Re: Resolution of Groundwater Comments, M-1980-183

Re: M-1980-183 Quarterly Groundwater Monitoring Results Submission

RE: Groundwater Mounding East of Pit 29 (Permit M-1980-183), Adams County, Colorado

Graph of Groundwater Elevations

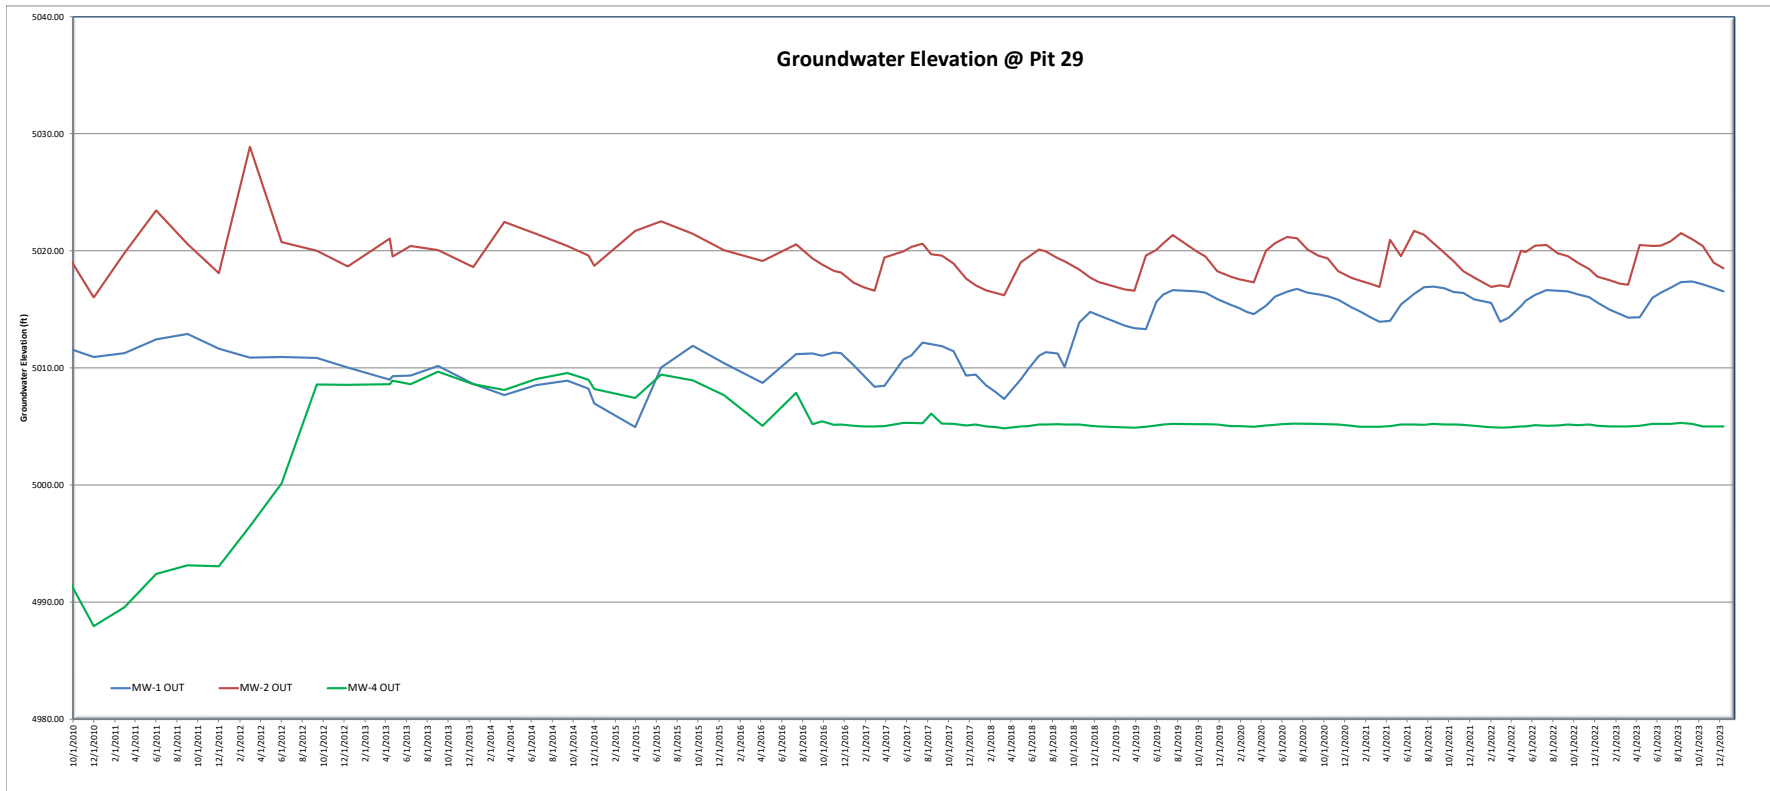
Stated concisely, data from MW-1 since the slurry wall repair in 2019, at the cited east side permit boundary, illustrates a rebounding effect from artificially depressed groundwater levels. For further explanation, enclosed is a supplementary engineering/hydrogeology letter from Civil Resources, LLC.

The Division alleges an "average" rise of approximately 5.5 feet in groundwater levels at MW-1 as the basis for its citation of Rule 3.1.6(1). It is unclear how this is measured as a disturbance, or as a failure to minimize disturbance, under Rule 3.1.6(1). Any attempt at quantification should account for climatic and seasonal

The hydrologic balance is being kept in check by the French drain, as verified by the readings from MW-4. There have not been any offsite impacts associated with hydrologic balance issues observed since the French drain was installed. MW-2 groundwater levels appear to be similar to previous years and are currently exhibiting seasonal fluctuations. MW-1 groundwater levels are exhibiting seasonal fluctuations. The groundwater levels in MW-1 have remained within a steady range since early 2019.

- c. Brannan’s impact on the local groundwater balance became negligible when the water levels recovered following repair of the slurry wall and ceasing pumping of the groundwater in 2019. The documented groundwater levels recovered following the slurry wall repair and have been stable over the last several years with water levels fluctuating seasonally within natural variability. Refer to Brannan’s letter latest Quarterly monitoring results.
